SUBJECT: REQUEST FOR PROPOSALS FOR PERFORMANCE OF EXPERT PROFESSIONAL SERVICES FOR NEWARK LIBERTY INTERNATIONAL AIRPORT TERMINAL A REDEVELOPMENT PROGRAM – DESIGN OF TWO MULTIPLE-SPAN BRIDGE STRUCTURES (RFP #43730) - ADDENDUM #2

Figure 1 - Bridges N58 and N59 Location Plan

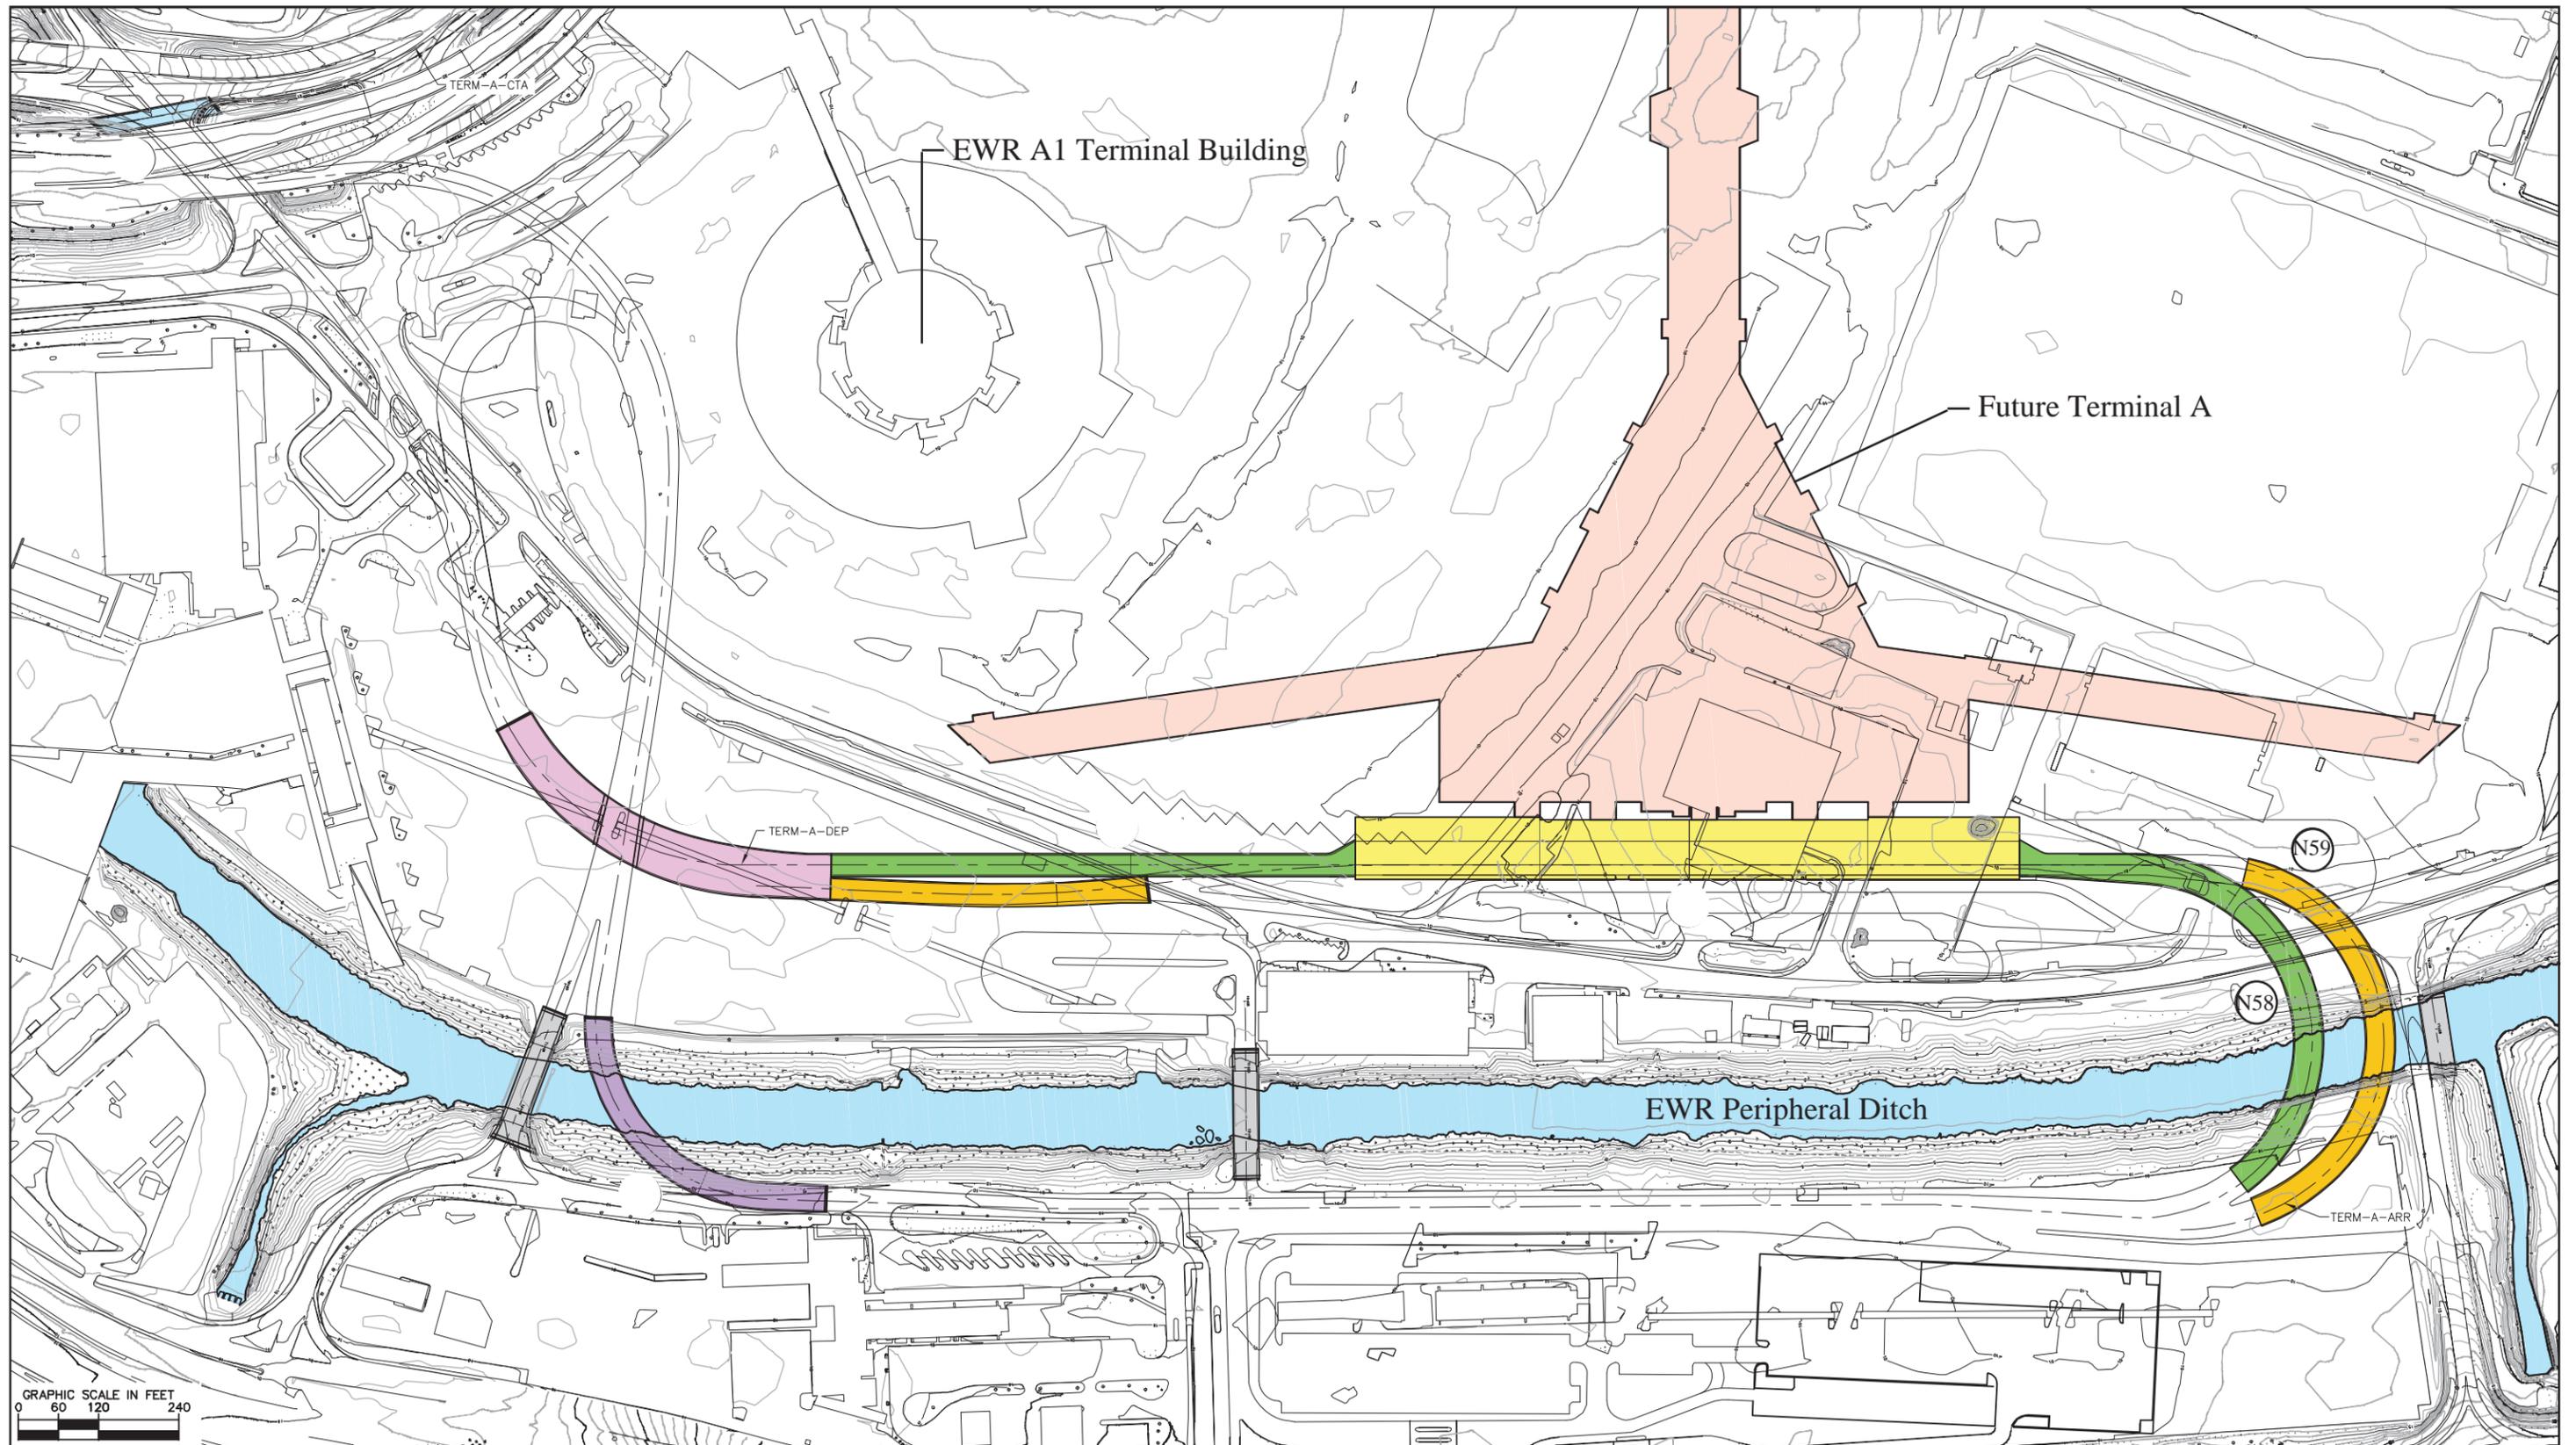
5. *Is a better quality (legible) version of Exhibit 1 - Figures 1, 2 & 3 available?*

Response: See attached for updated copies of Exhibit 1 - Figures 1, 2 & 3 in PDF.
